January 31, 2023

**RE: RE: Phil Chacon Memorial Substation SE Area Command Addition
800 Louisiana Blvd. SE
Grading and Drainage Plan – Phase 2
Engineer's Stamp Date: 1/27/2023
Hydrology File: L19D043**

DRAWING TITLE:
PHASE 2 SITE GRADING PLAN

A1 PHASE 2 SITE GRADING PLAN
1" = 20'-0"

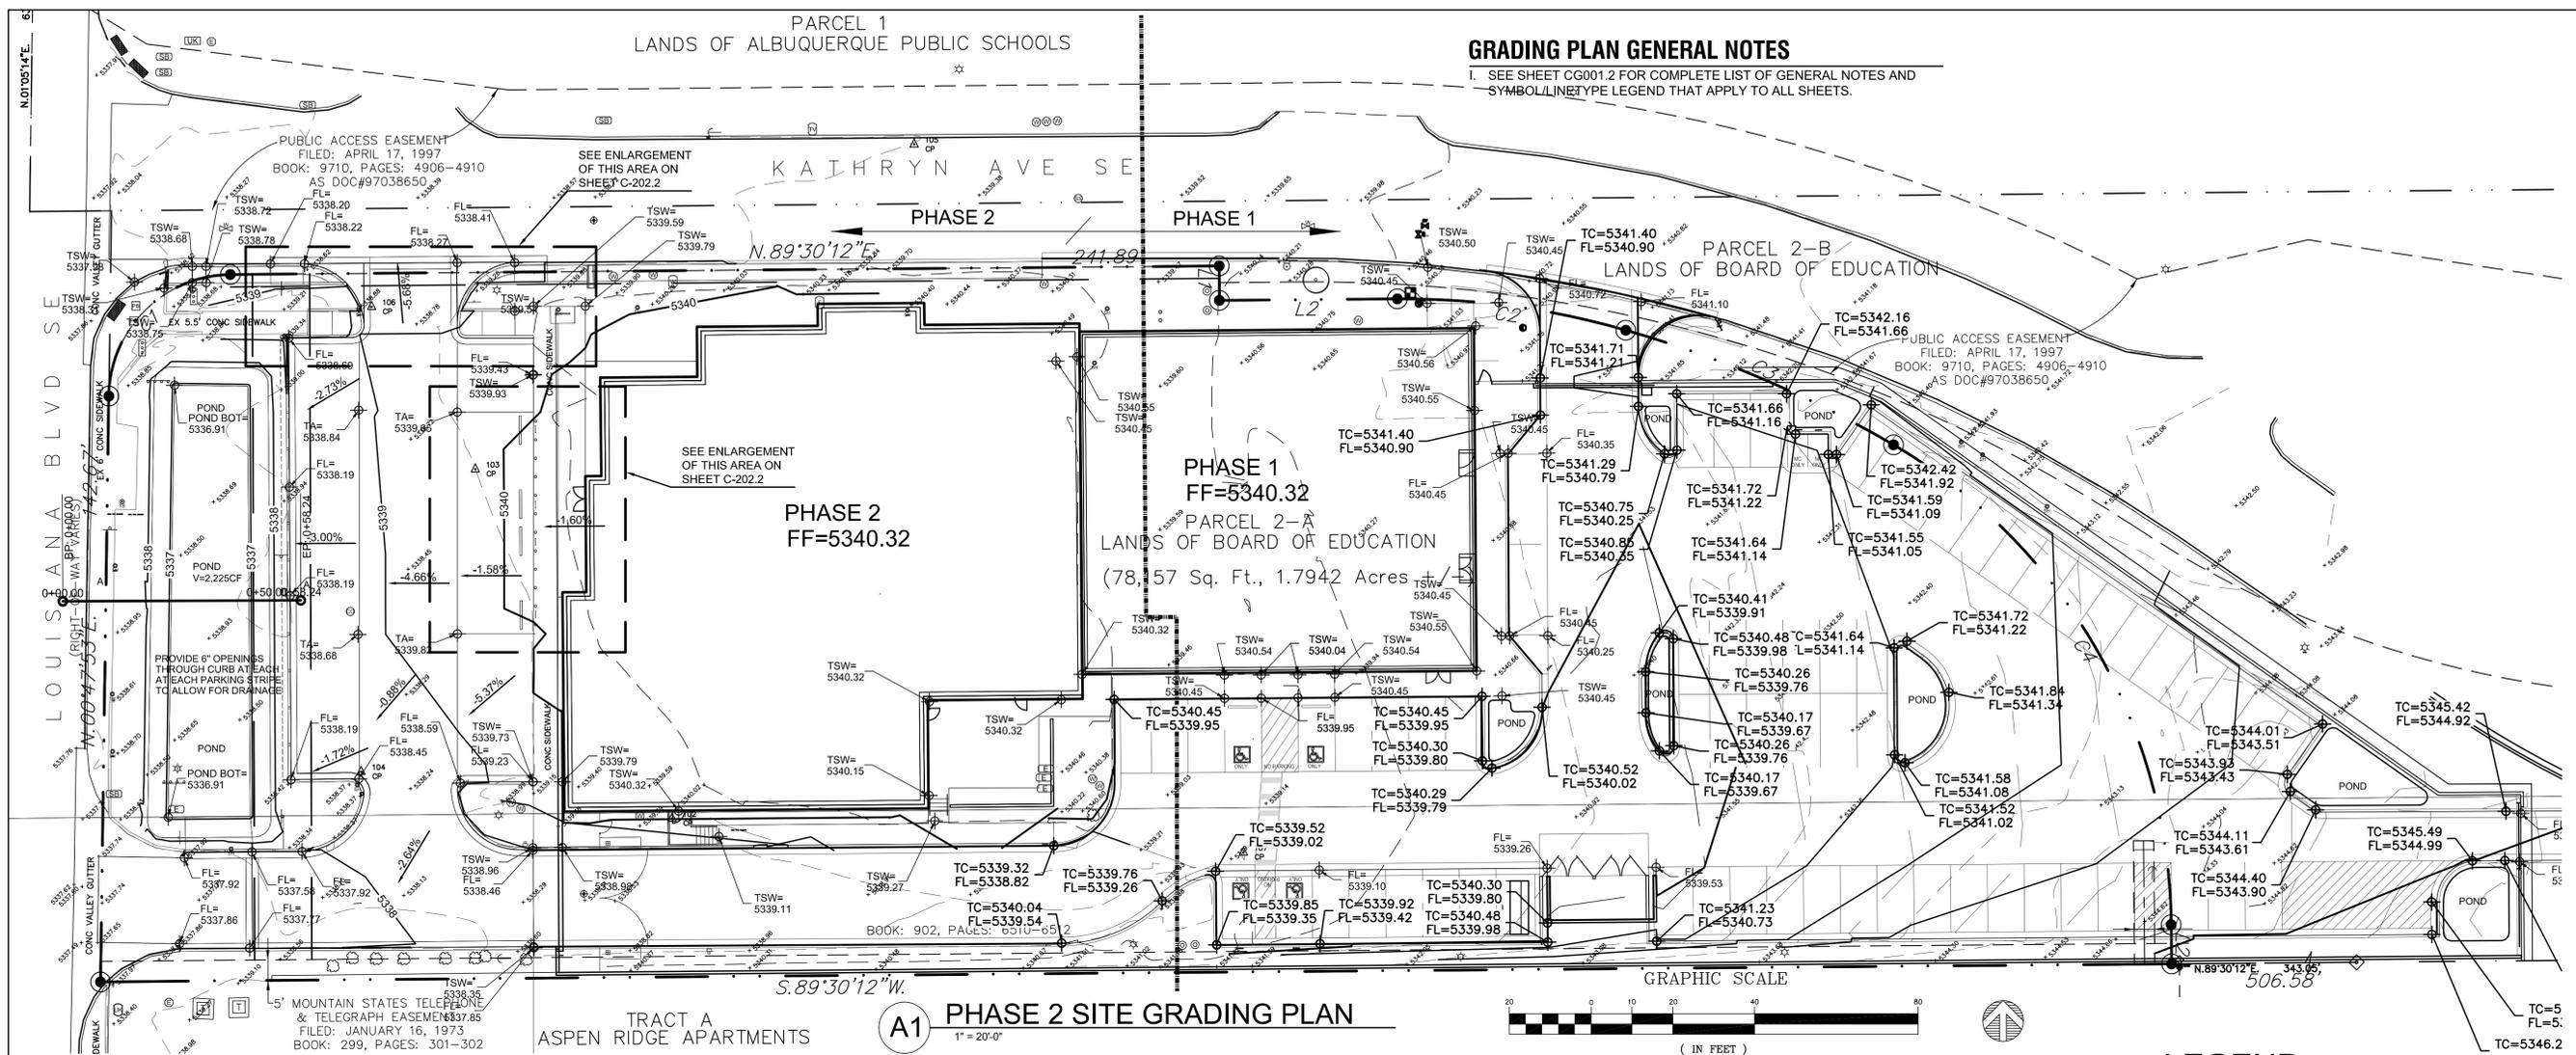
Based upon the information provided in your submittal received 1/30/2023, the Grading & Drainage Plan is approved for Building Permit approval. Please attach a copy of this approved plan in the construction sets for Building Permit processing along with a copy of this letter.

Engineer's Certification, per the DPM Part 6-14 (F): *Engineer's Certification Checklist For Non-Subdivision* is required.
